PLANNING COMMISSION  
MEETING AGENDA  
NOVEMBER 14, 2023  
7:00 P.M.

**Wawa  
390 Glensprings Drive  
Corridor Review District  
Application# 2023-0764  
November 14, 2023**

**Chick-fil-A**  
**501 East Kemper Road**  
**Modification to a PUD and Zone Map Amendment**  
**Application# 2023-0739**  
**November 14, 2023**

**CHICK-FIL-A**  
**501 E. KEMPER ROAD**  
**PLAN REVIEW APP # 20230739**  
**19020115**  
**NOVEMBER 10, 2023**

SHEET  
**PERMIT Landscape Plan**  
 SHEET NUMBER  
**L-100**

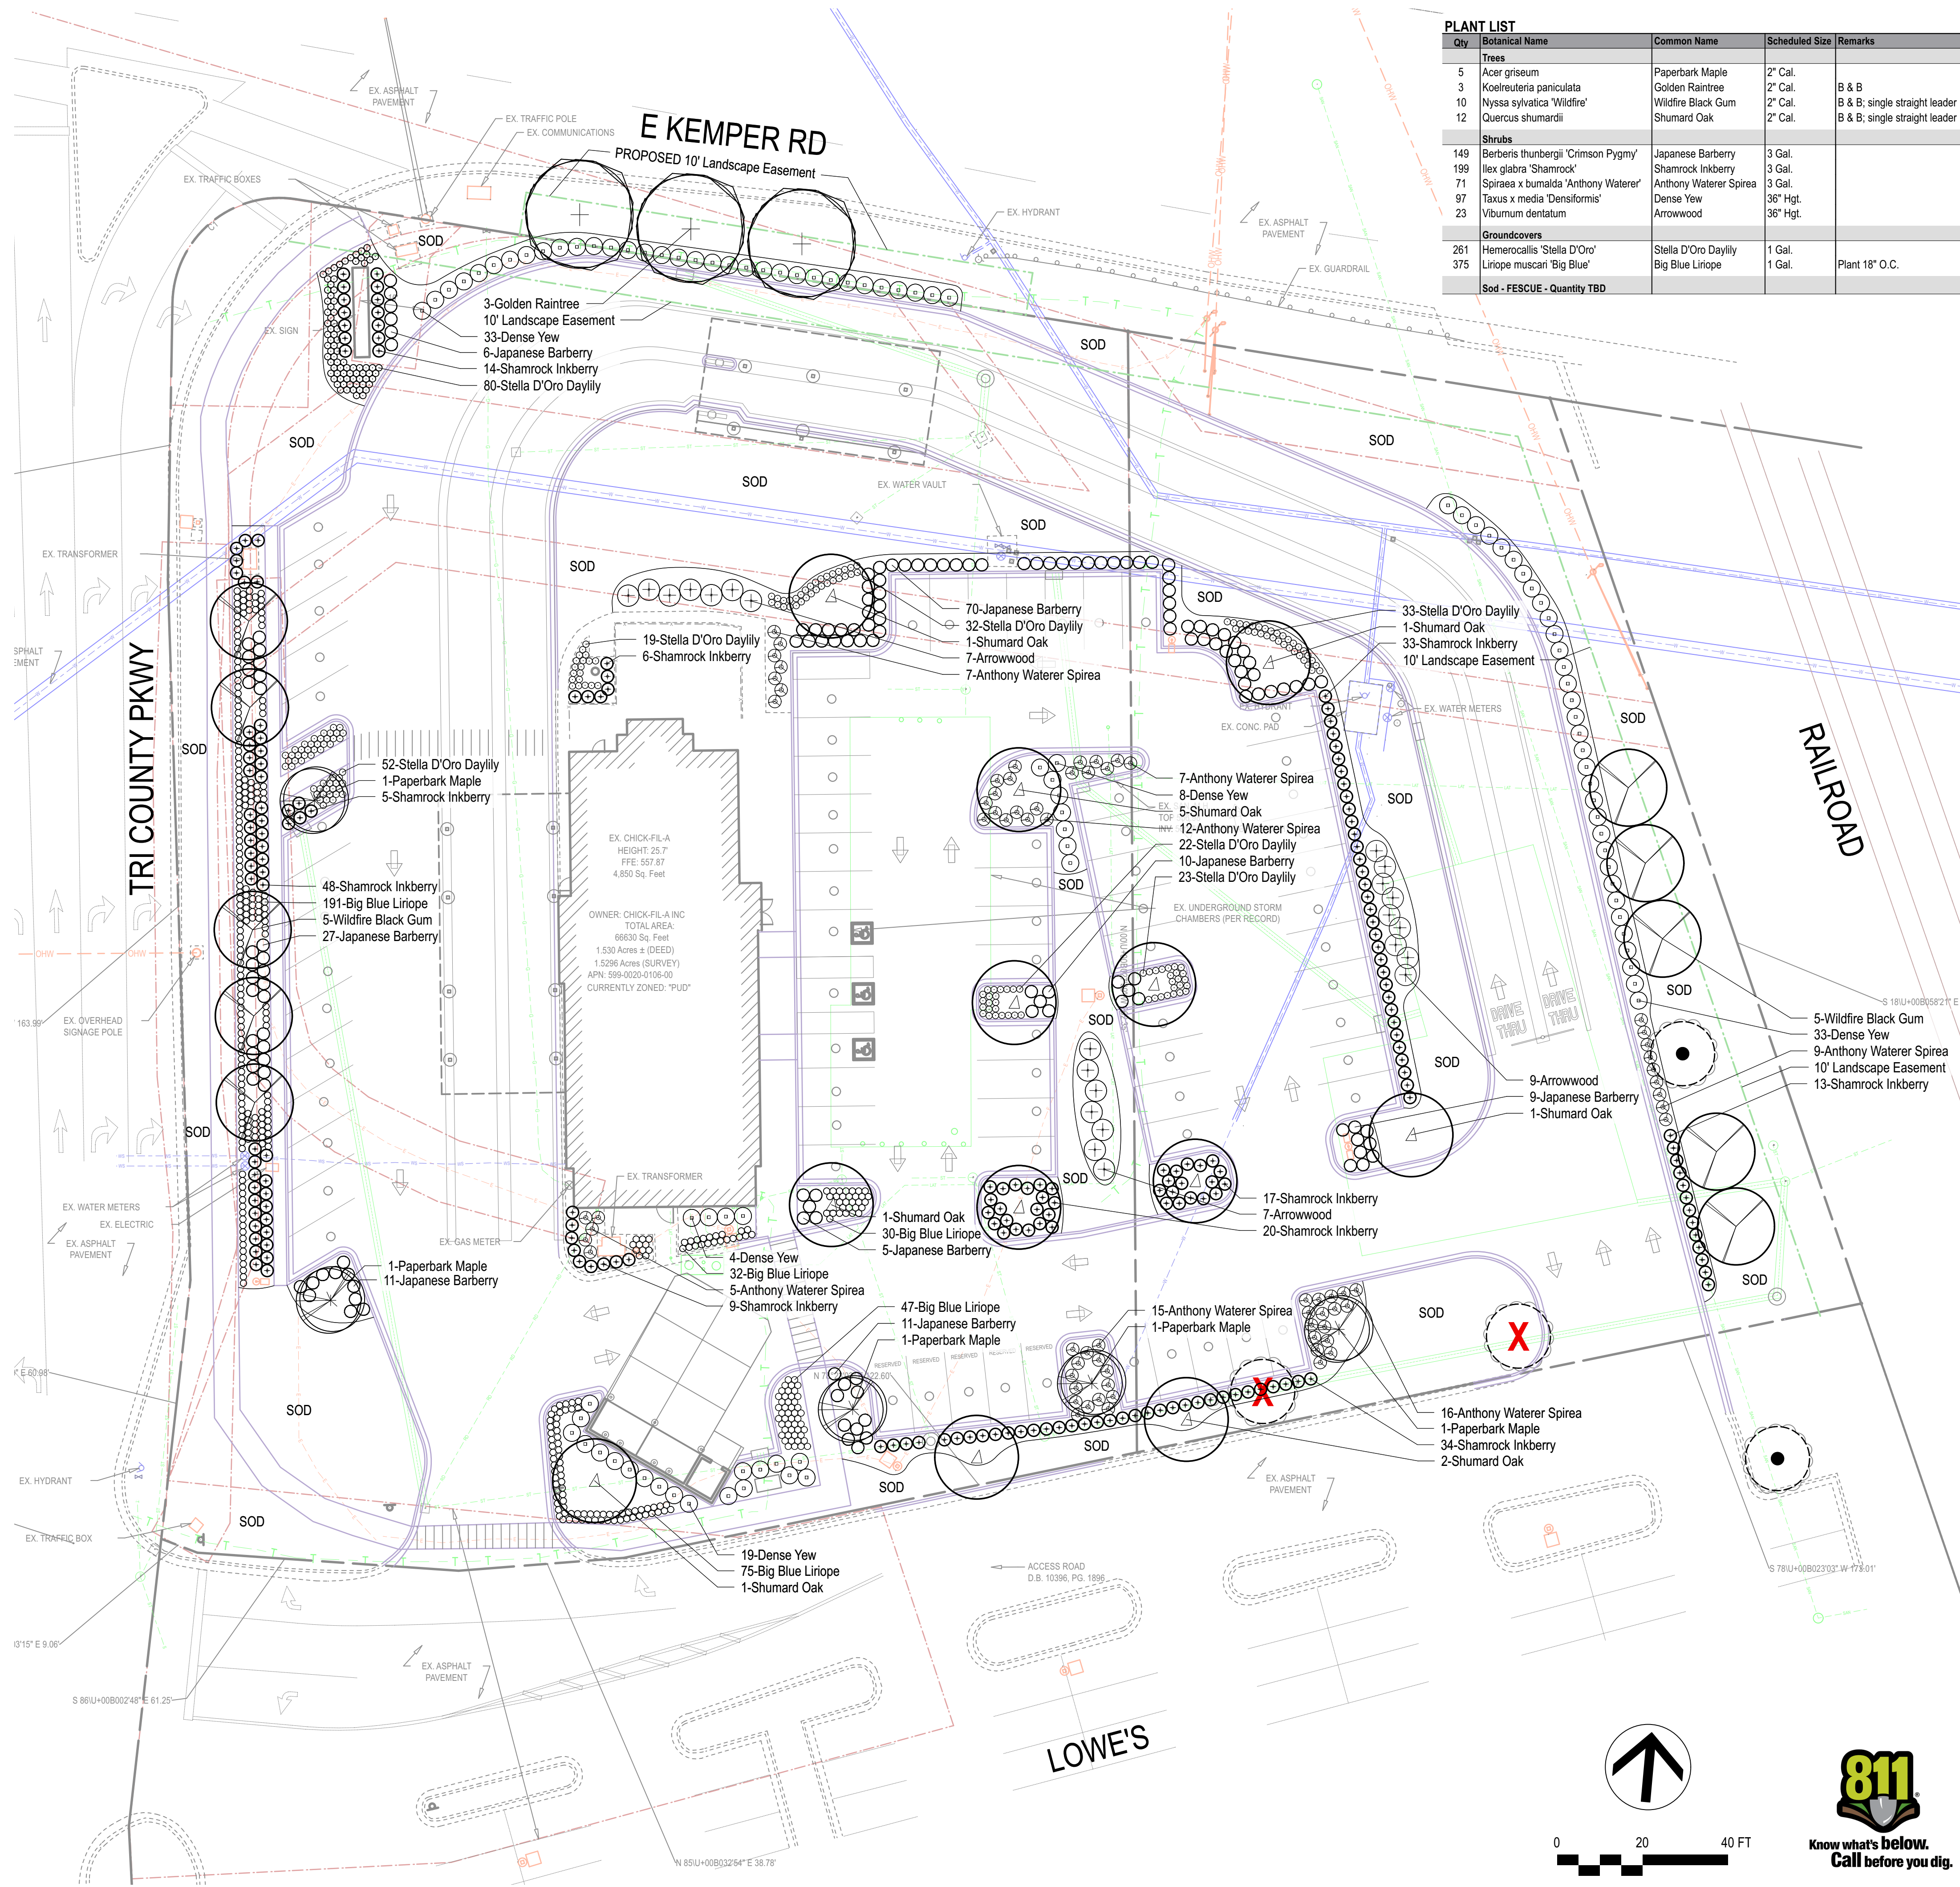
- 8) A landscape plan was submitted to which staff has the following comments:
  - A) There is no Landscape Plan uploaded in this latest submission. The Landscape Comment response letter, dated 10.30.2023, states bufferyard plant quantities were updated, however there is no plan.

- B) The Landscape Comment response letter states that a tree survey is forthcoming and existing tree locations were temporary added to the Plan based on Google Maps imagery. The plan set needs to accurately identify all the trees are their current size to be removed even if they were planted as part of the recent site improvements.

- C) Plant diversity is provided, however the plant quantities should be spread equally amongst the different species. Shrub quantities need to be more equally divided.

The Applicant requested clarification on the requirement in the code. Plant material diversity, with even distribution, is required per Section 153.403 (E).

- 7) The Landscape Plan be revised per staff comments.
- 8) The relocated waste enclosure will comply with all the requirements of Section 153.254 (G).

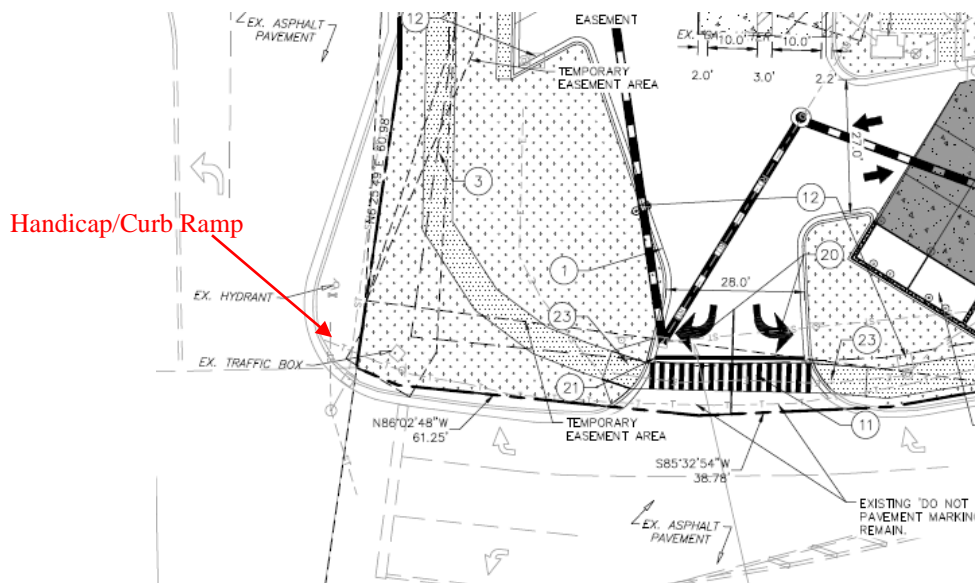
1. The sidewalk tie-in shall be revised to better align with the existing ramp. The sidewalk at this location may need to be wider and located at the back of curb. The submitted site plan dated October 30, 2023, noted that the proposed connection to the existing curb ramp is to be finalized in the construction drawings.
2. The site plans shall also be revised to extend the sidewalk to the curb at the shared entrance drive along Tri-County Parkway and construct a handicap/curb ramp. The curb ramp shall be oriented for a future ramp to the south crossing the shared entrance roadway.

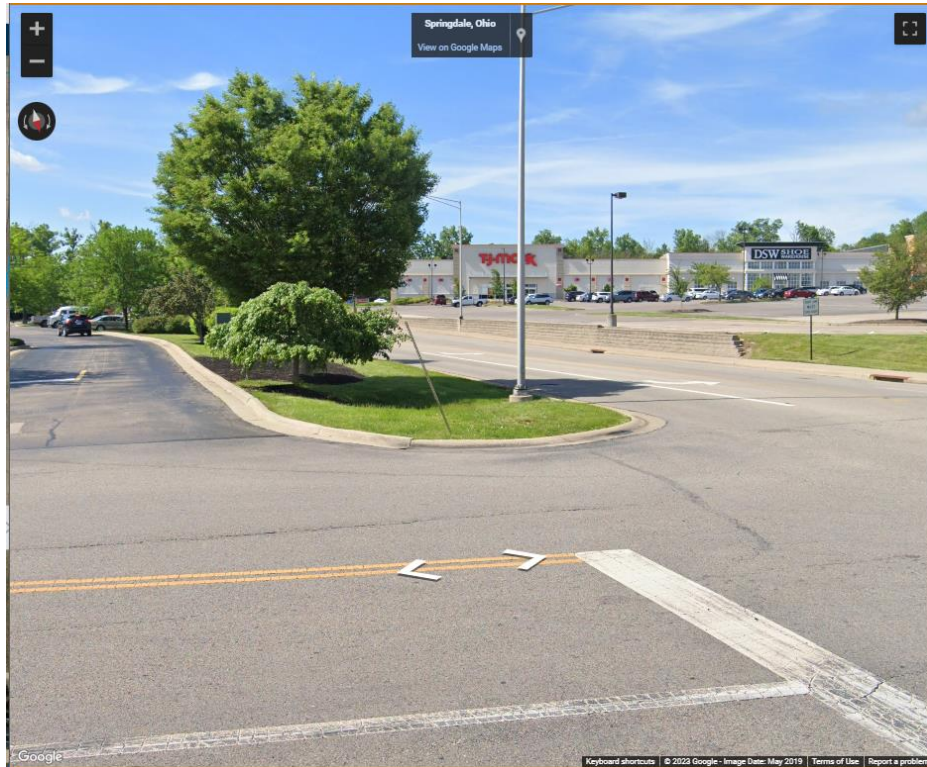
7. There is a concern with the site distance at the intersection of the at the shared entrance drive along Tri-County Parkway. It is recommended that the applicant coordinate with the adjoining property owner to the south to improve the situation.

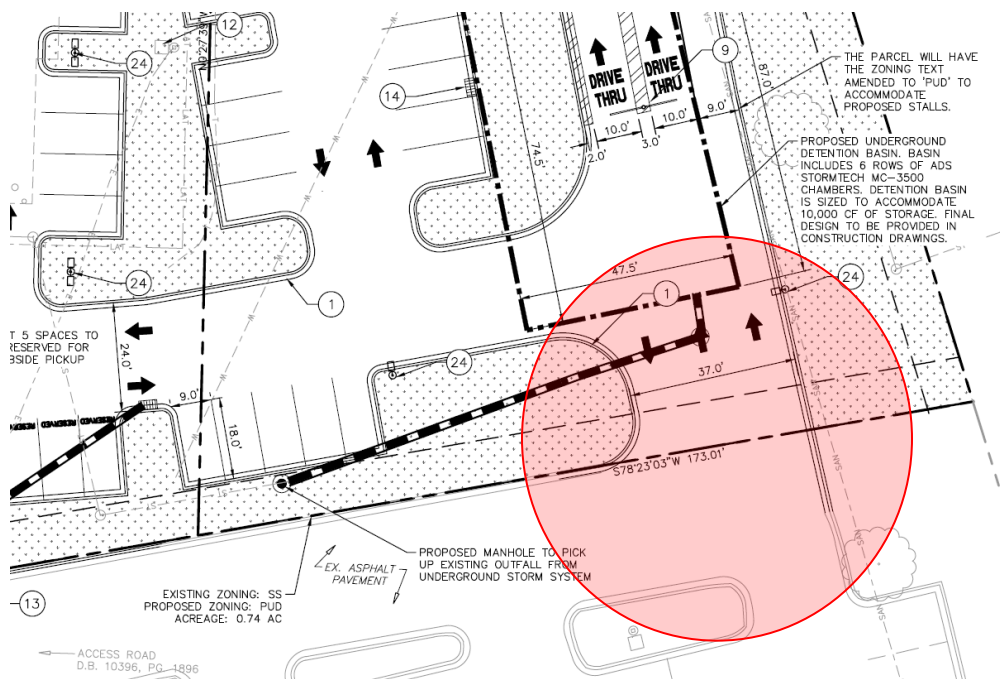
8. It is recommended that the western entrance be reduced to two lanes (entrance lane and exit lane).
